Modification/Change Order No.6

EWP – Oyster Creek Channel Bank Stabilization Phase II

RE: Modification Pricing Request – Realignment of Site 428

DRAWING NO. TX-EN-0791
SHEET NO. 2
OF 11

PLAN VIEW - SITES 428 & 429

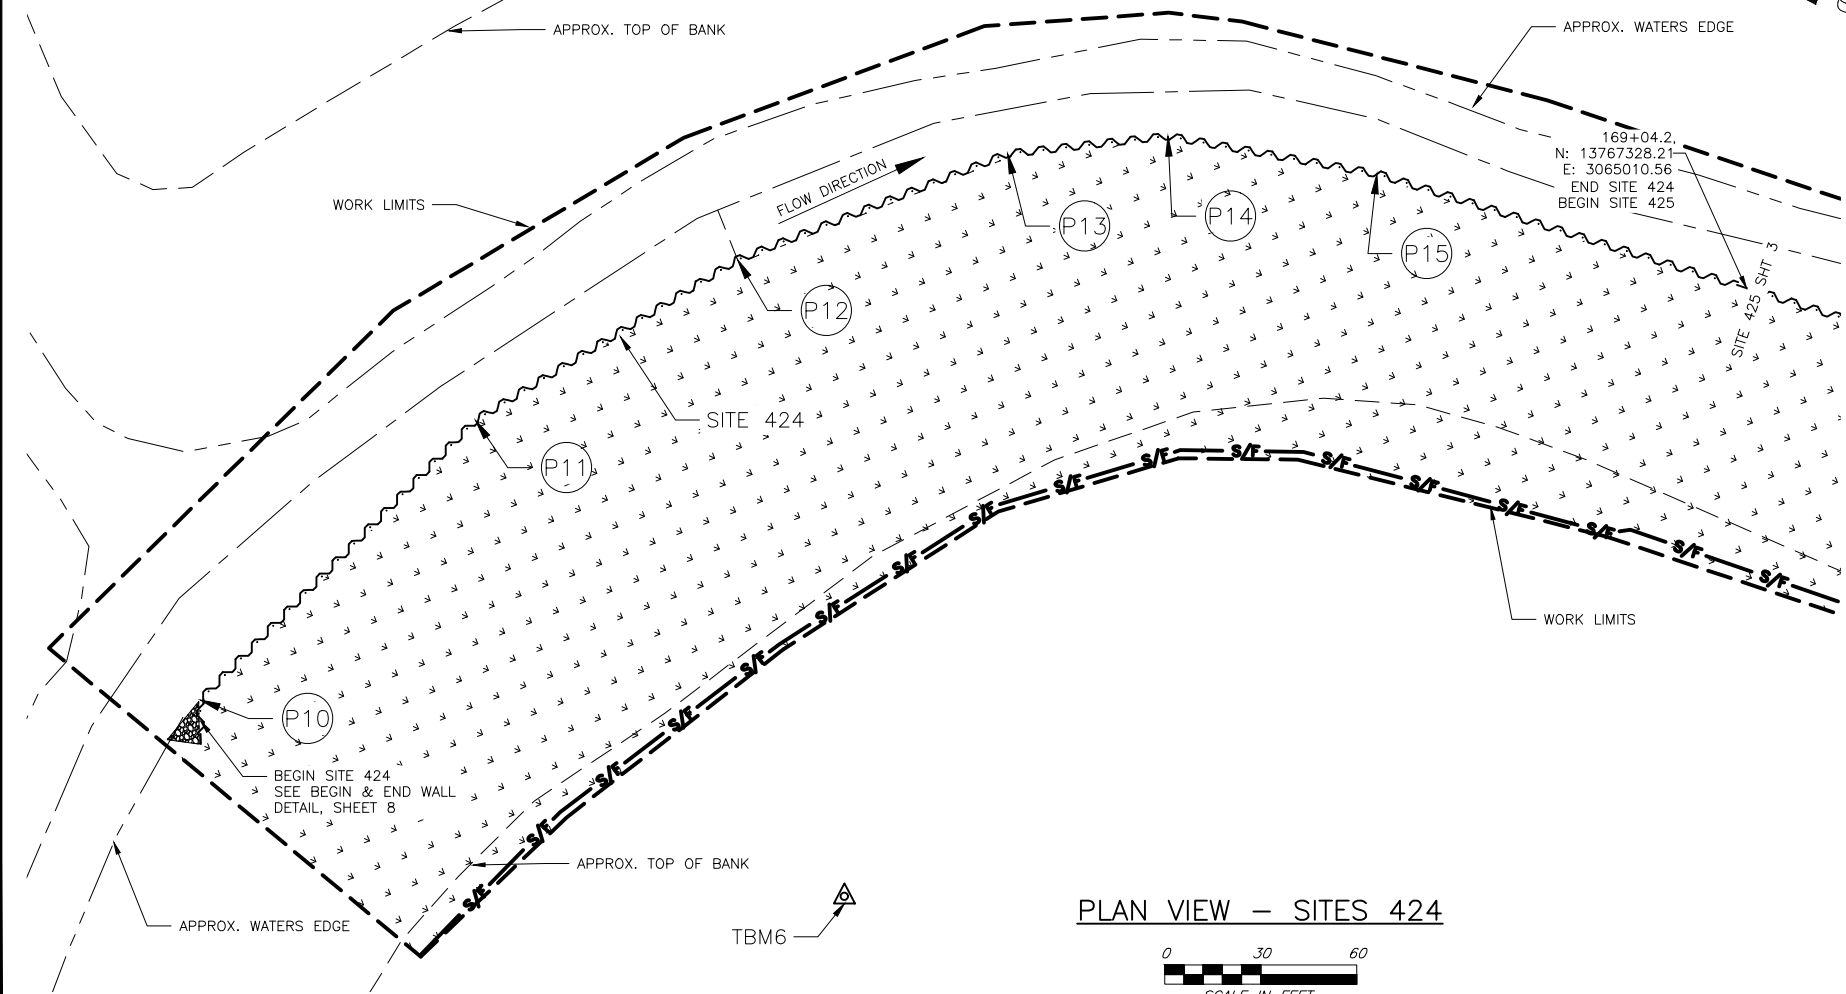
Contractor shall furnish all material, equipment and labor to place relocate the steel sheet pile wall on Site 428 (P4 to P5) as shown on the attached drawing. Materials shall be salvaged and reused to complete the required wall. Compensation for this change is lump sum as shown below.

NBG Constructors, Inc. respectfully submits lump sum pricing of \$47,500 to completely remove and replace approximately one-hundred, fifty-eight (158) feet of completed sheet pile wall to facilitate the revised alignment. The pricing is predicated on being able to reuse all existing materials, except for both the coarse and fine drain fill.

REVISIONS		
DATE	APPROVED	TITLE
3/31/21	BTS	WALL HEIGHT ADJUSTMENT
8/2/21	BTS	STEEL I-BEAM PILING ADDED
9/1/21	BTS	ADJUSTED LOCATION P4 & P6
10/20/21	BTS	ADJUSTED LOCATION P5
